HISTORIC AND DESIGN REVIEW COMMISSION

HDRC CASE NO: 2024-215
ADDRESS: 401 KENDALL ST
LEGAL DESCRIPTION: NCB 1744 BLK 12 LOT S 50 FT OF 5 & 6 ARB A-7
ZONING: MF-33, H
CITY COUNCIL DIST.: 1
DISTRICT: Tobin Hill Historic District
APPLICANT: Shannon M Follansbee | KEN 401 LLC
OWNER: Shannon M Follansbee | KEN 401 LLC
TYPE OF WORK: Conceptual review of additions and alterations
APPLICATION RECEIVED: June 10, 2024
60-DAY REVIEW: August 9, 2024

401 KENDALL STREET
SAN ANTONIO, TX

SHEET:
A-6

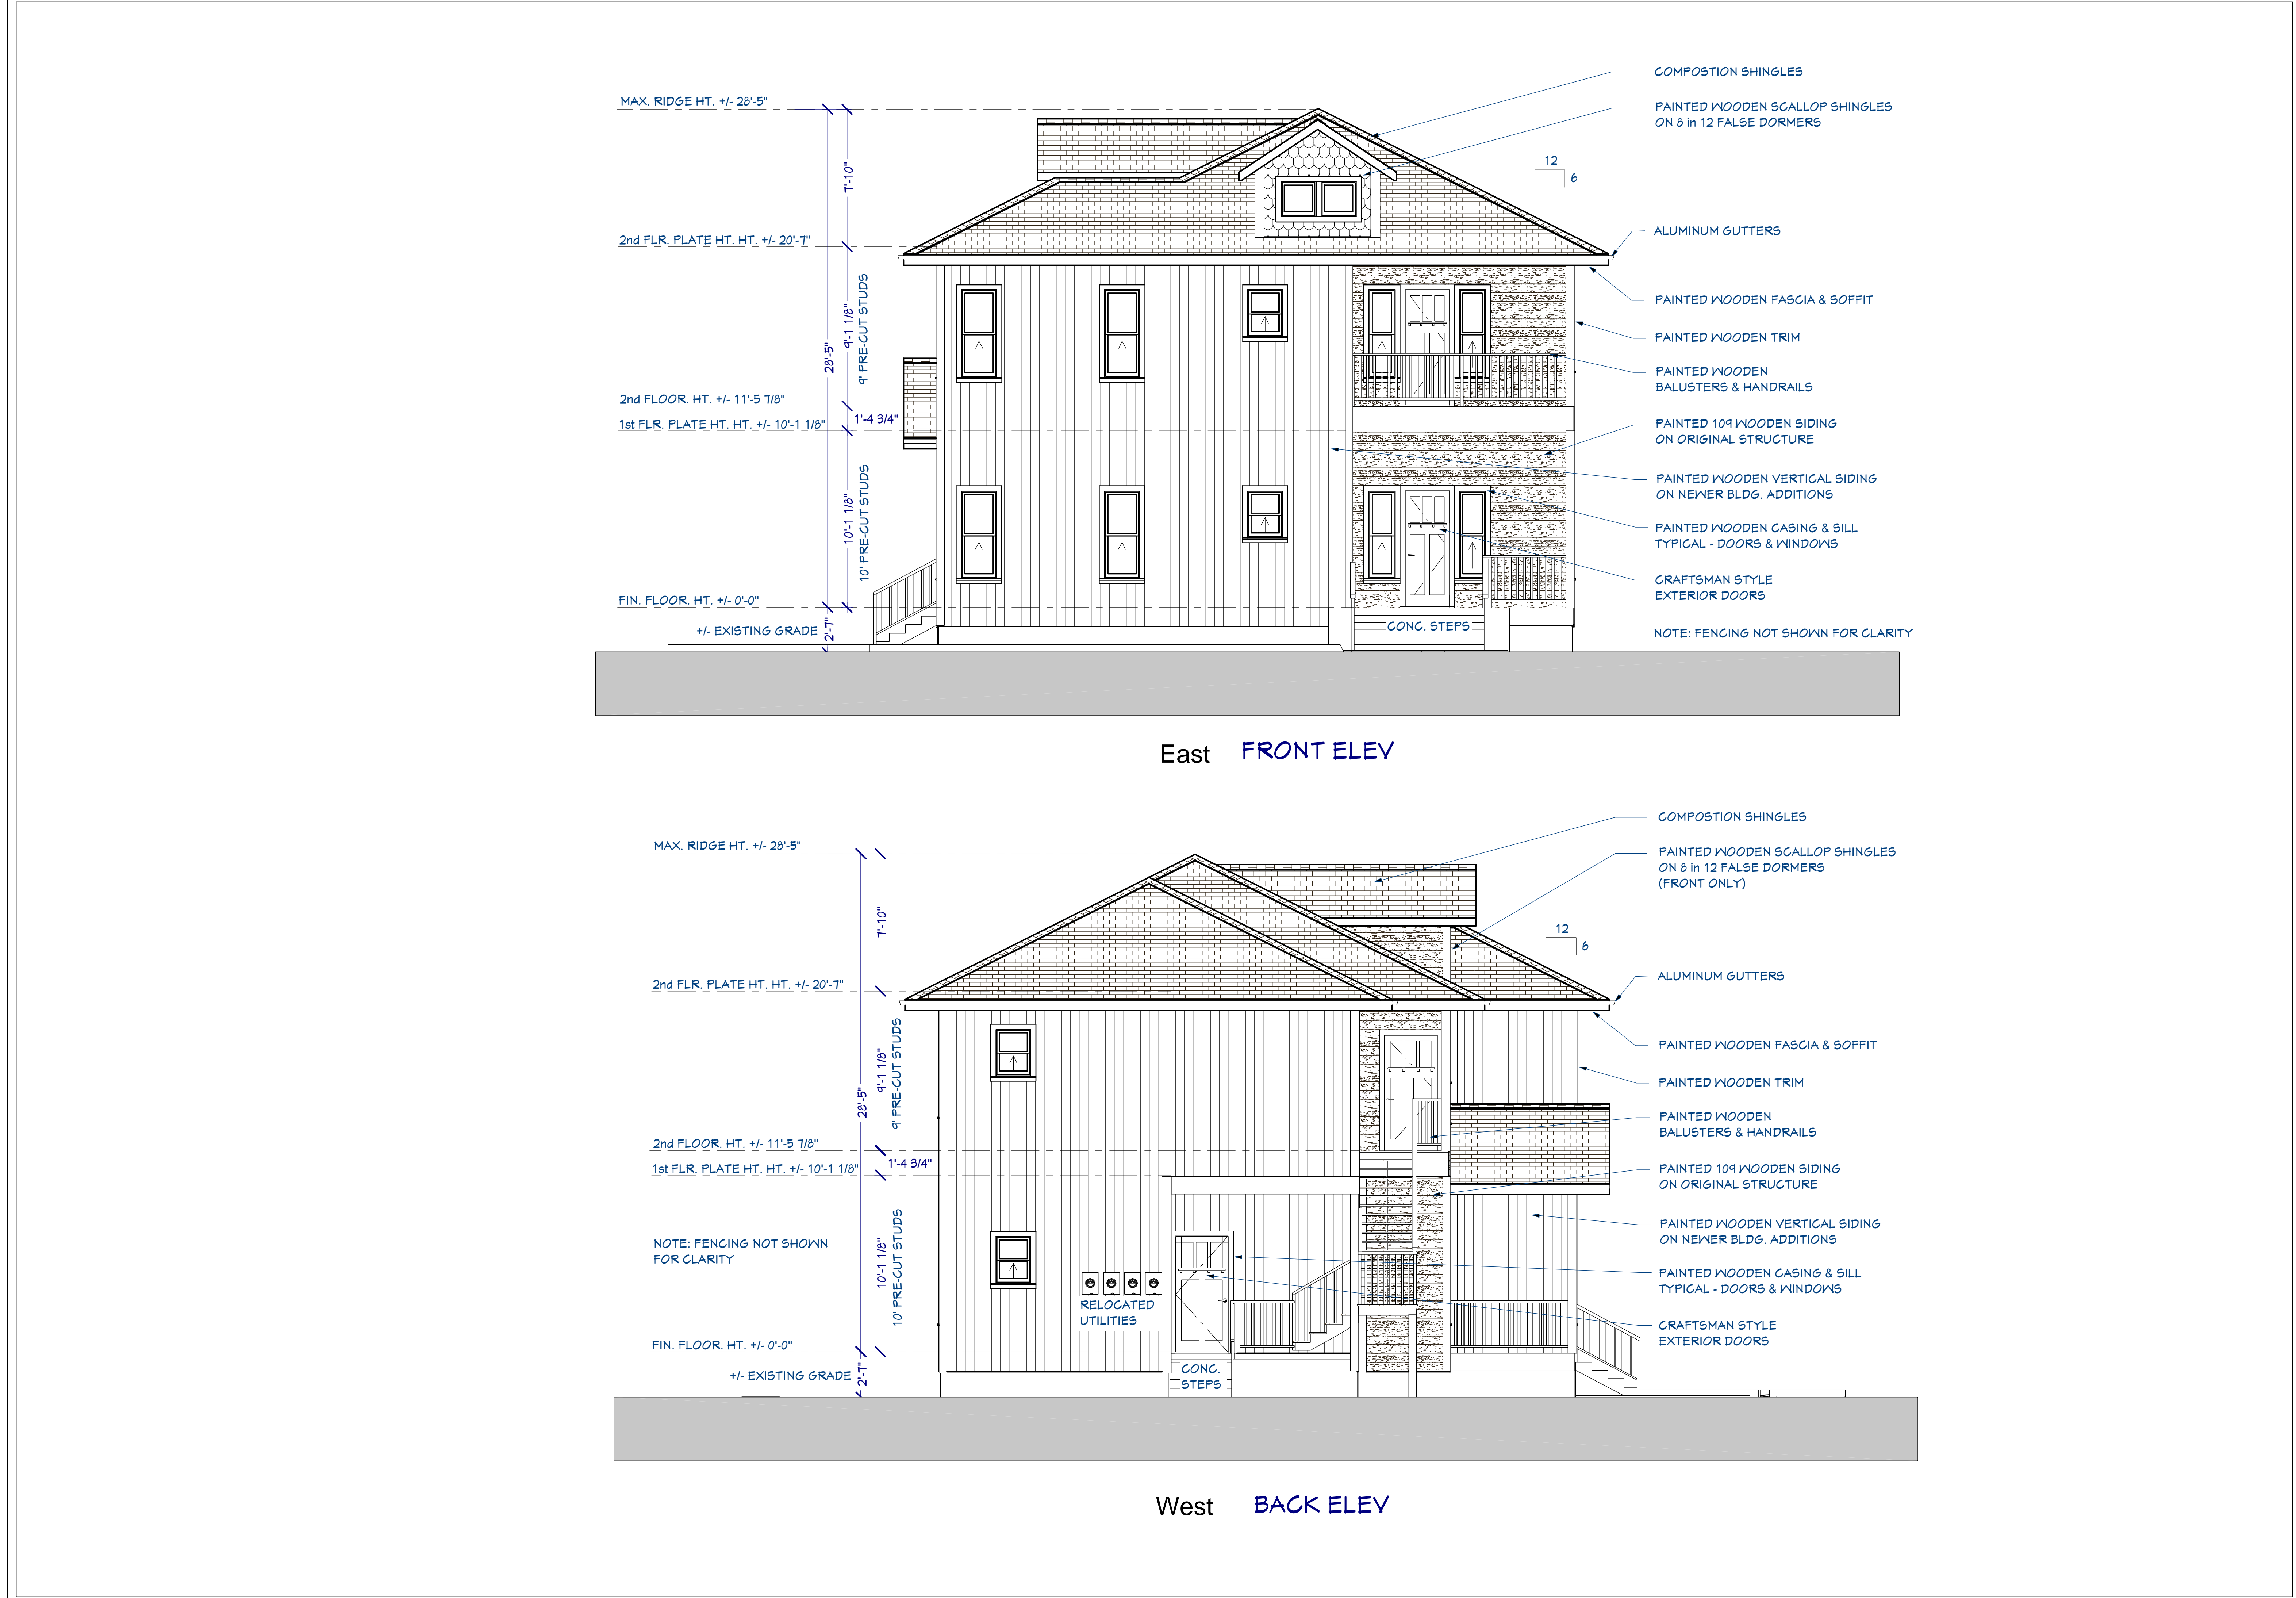
- p. **FENESTRATION MODIFICATIONS (FRONT: EAST)** – The applicant is requesting conceptual approval to modify the existing fenestration pattern on the front façade to include the removal of two doors and all window openings, and the installation of two doors and ten one-over-one windows. On the front façade, the existing recessed porch's back wall is a part of the historic footprint of the property; however, other walls on this façade are from later additions. The Historic Design Guidelines for Exterior Maintenance and Alterations 6.A.i. states to preserve existing window and door openings, to avoid enlarging or diminishing to fit stock sizes or air conditioning units, and to avoid filling in historic door or window openings. Exterior Maintenance and Alterations 6.A.iii. states to preserve historic windows. Exterior Maintenance and Alterations 6.B.iv. states to install new windows to match the historic or existing windows in terms of size, type, configuration, material, form, appearance, and detail when original windows are deteriorated beyond repair. Exterior Maintenance and Alterations 6.B.vii. states to replace non-historic incompatible windows with

windows that are typical of the architectural style of the building. Windows located at this property are no longer present and existing doors are not complementary to the architectural style of the property. Staff finds that some modifications to the front fenestration pattern are generally appropriate. However, any changes should respect traditional proportions and the existing groupings of windows which reveal the original, two-story front porch configuration.

- s. **TWO-STORY PORCH REOPENING (FRONT: EAST)** – The applicant is requesting conceptual approval to modify the existing two-story front addition by reopening a portion of the previously enclosed second-story porch and expanding the footprint to align with the north wall plane. The proposed reopened porch includes the installation of wood railing, wood balusters, and square columns. Exterior Maintenance and Alterations 7.B.iii. states to replace in-kind porches and related elements, such as ceilings, floors, and columns, when such features are deteriorated beyond repair, and when in-kind replacement is not feasible, the design should be compatible in scale, massing, and detail while materials should match in color, texture, dimensions, and finish. Exterior Maintenance and Alterations 7.B.v. states to reconstruct porches based on accurate evidence of the original, such as photographs, and if no such evidence exists, the design should be based on the architectural style of the building and historic patterns. Staff finds the proposed front porch modifications generally consistent with the Guidelines; however, the footprint of the second-story porch and location of the northeast column should remain.

- u. **ROOF FORM MODIFICATIONS** – The applicant is requesting conceptual approval to modify the roof line over the previously-enclosed front porch and front addition. Additionally, the applicant is requesting conceptual approval to remove the existing gable dormers and replace them with false dormers. The applicant has noted to staff that the included 3D renderings of the proposed modifications do not accurately represent the request for roof form modifications. However, the renderings accurately reflect the applicant's other request items. Exterior Maintenance and Alterations 3.B.ii. state to preserve the original shape, line, pitch, and overhang of historic roofs when replacement is necessary. Exterior Maintenance and Alterations 3.B.iii. states to preserve and repair distinctive roof

features such as cornices, parapets, dormers, open eaves with exposed rafters and decorative or plain rafter tails, flared eaves or decorative purlins, and brackets with shaped ends. The applicant has noted fire damage as a reason for the removal of the existing front-facing gable dormers and replacement with false dormers. The dormers present are character-defining features to this property. Additionally, the applicant has noted the reason for roof form modifications over the previously enclosed front porch and addition is to simplify the overall roof form. Staff finds the proposed modifications to the roof form and replacement of the existing dormers do not conform to Guidelines. The applicant should maintain the existing roof forms and repair damaged structural framing if necessary to maintain the existing dormers.

Item 3: Staff does not recommend approval of the modification to the existing fenestration pattern on the property, based on the findings. All original window location, sizes, and configurations should remain intact or only modified slightly in location to accommodate changes in floor plan. Staff recommends the addition of new, traditionally-dimensioned windows in the front (east) facade at the location of the non-original front addition. Selected window products must meet staff's standards for wood windows including the installation of full side-lite windows on either side of the front door.

Item 4: Staff recommends conceptual approval of the partial reopening of the second story porch on the front façade, based on findings a through c and finding s, with the following stipulations:

- i. That the porch footprint and corner column locations not exceed the current footprint of the enclosed porch.
- ii. That column design and specifications be submitted to staff for final review. Generally, columns should feature chamfered corners and a traditional cap and base.
- iii. That the applicant install window products must meet staff's standards for wood windows including the installation of full side-lite windows on either side of the front door.

Item 6: Staff does not recommend conceptual approval of the roof form modifications, based on findings a through c and finding u. Staff recommends the applicant retain the existing roof forms and reconstruct the damaged dormers in situ if beyond repair.

A-7

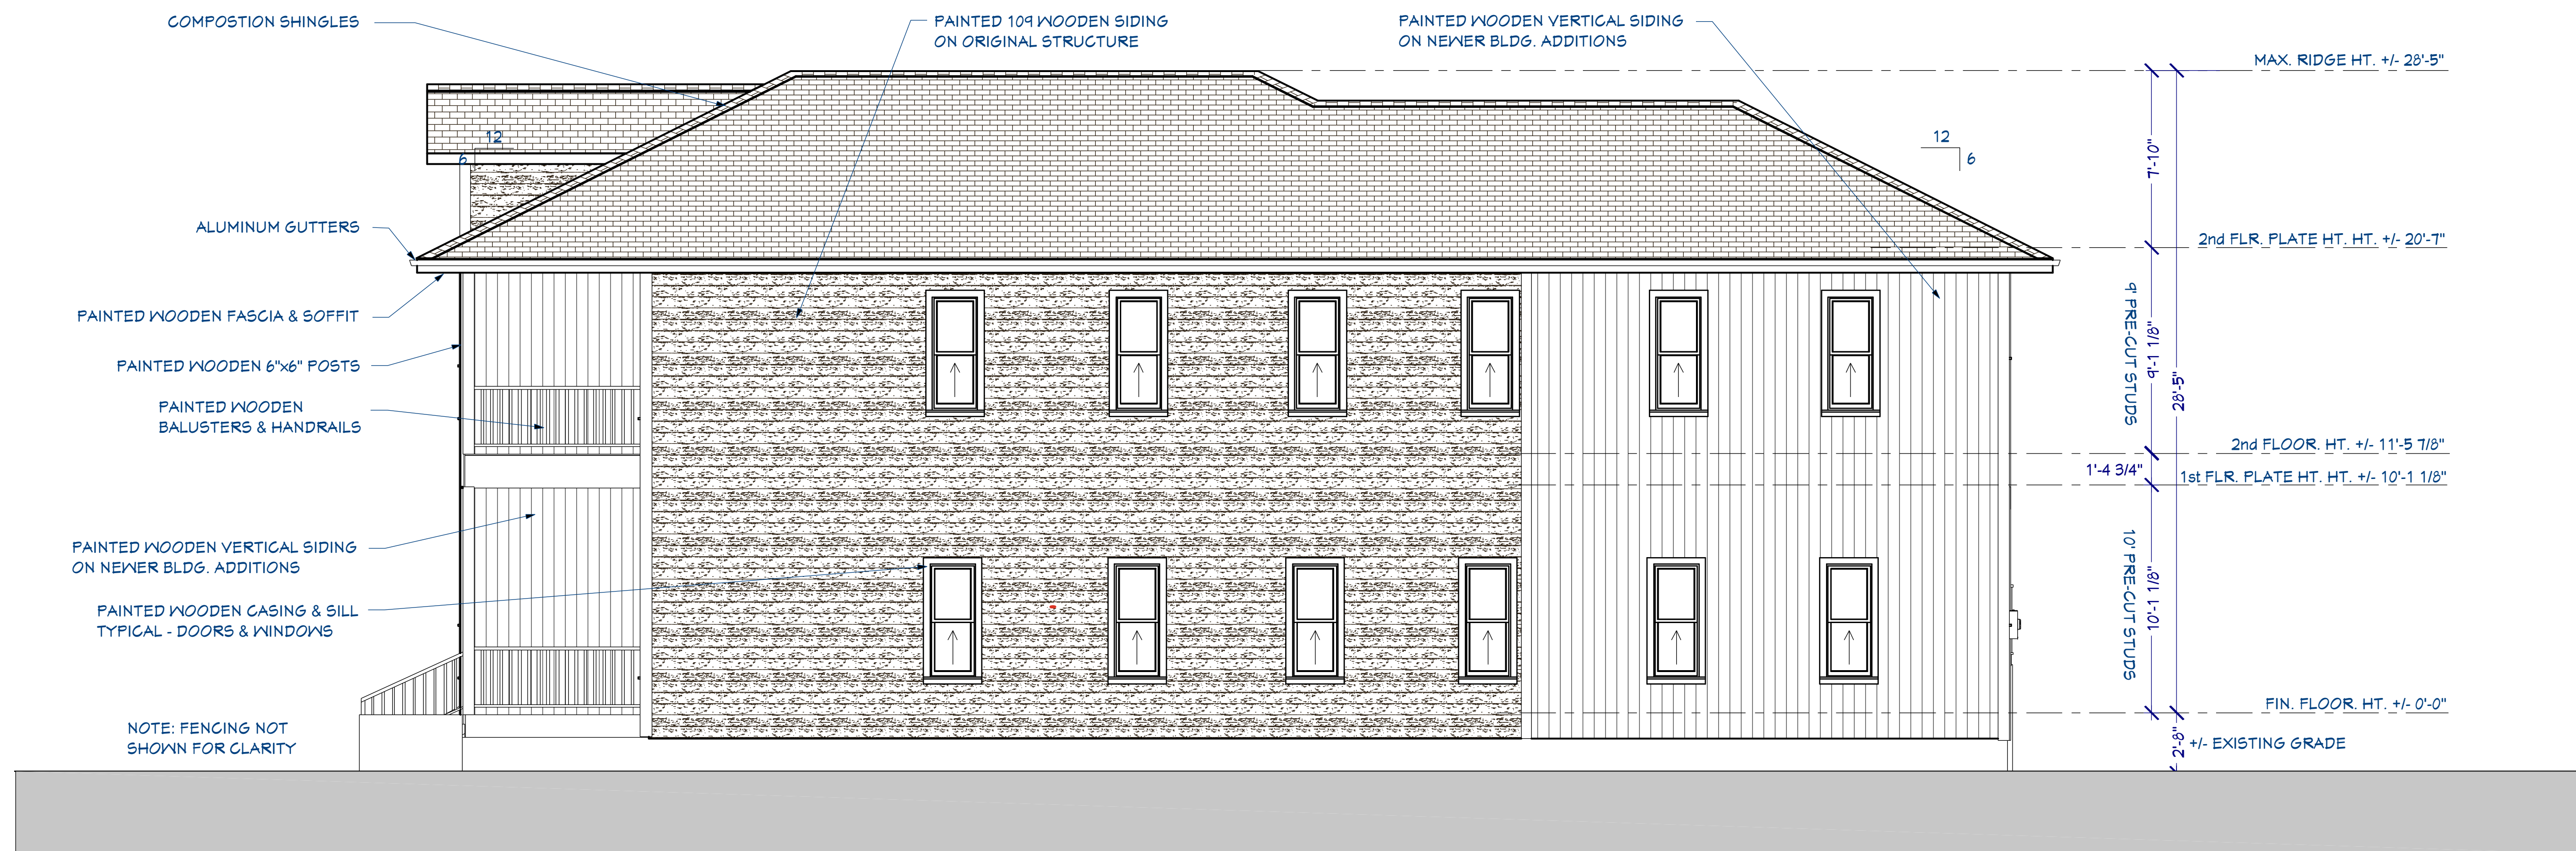
- o. **PORCH MODIFICATIONS (SOUTH: E MYRTLE ST)** – The applicant is requesting conceptual approval to modify the existing porch facing E Myrtle St. The existing porch and entryway are not original to the property and does not appear in the 1951 Sanborn Map. In addition, this existing porch features a hipped roof, a single door opening with sidelites, a concrete landing, and concrete steps. The applicant has proposed a porch configuration featuring two door openings, a front-facing gable roof decorated with wood scallop shingles, a composition shingle roof, closed eaves, and porch columns, decking, stairs, and railing of unspecified material and dimensions. The applicant has also proposed to reposition the porch underneath the proposed front-facing gable false dormer. Staff finds that the introduction of a prominent front porch to this modified structure confuses the historic design of the home which historically faces Kendall Street. A simplified stoop design that provides shelter for the side entrances would be more consistent with the Guidelines.

- q. **FENESTRATION MODIFICATIONS (RIGHT: NORTH)** – The applicant is requesting conceptual approval to modify the existing fenestration pattern on the right façade to include the removal of five window openings and installation of eight one-over-one windows. Additionally, the applicant is requesting conceptual approval to remove the two existing oriels. Exterior Maintenance and Alterations 6.A.i. states to preserve existing window and door openings, to avoid enlarging or diminishing to fit stock sizes or air conditioning units, and to avoid filling in historic door or window openings. Exterior Maintenance and Alterations 6.A.iii. states to preserve historic windows. Exterior Maintenance and Alterations 6.B.iv. states to install new windows to match the historic or existing windows in terms of size, type, configuration, material, form, appearance, and detail when original windows are deteriorated beyond repair. Exterior Maintenance and Alterations 6.B.vii. states to replace non-historic incompatible windows with windows that are typical of the architectural style of the building. Staff finds the proposed fenestration pattern does not conform to Guidelines. The applicant should retain existing oriels in-place and maintain or reopen any historic window openings found on this façade.

- r. **FENESTRATION MODIFICATIONS (LEFT: SOUTH)** – The applicant is requesting conceptual approval to modify the existing fenestration pattern on the left façade to include the removal of one door and five window openings and to install two door and five window openings. Exterior Maintenance and Alterations 6.A.i. states to preserve existing window and door openings, to avoid enlarging or diminishing to fit stock sizes or air conditioning units, and to avoid filling in historic door or window openings. Exterior Maintenance and Alterations 6.A.iii. states to preserve historic windows. Exterior Maintenance and Alterations 6.B.iv. states to install new windows to match the historic or existing windows in terms of size, type, configuration, material, form, appearance, and detail when original windows are deteriorated beyond repair. Exterior Maintenance and Alterations 6.B.vii. states to replace non-historic incompatible windows with windows that are typical of the architectural style of the building. Staff finds the proposed fenestration modifications generally appropriate; however, the historic fenestration pattern should be retained on the historic footprint of the structure.

Item 2: Staff recommends conceptual approval of the E Myrtle-facing porch modifications, based on findings a through c and finding o, with the following stipulations:

- i. That the applicant revise their porch request to include a simplified stoop design that provides shelter for the side entrances to be more consistent with the Guidelines.
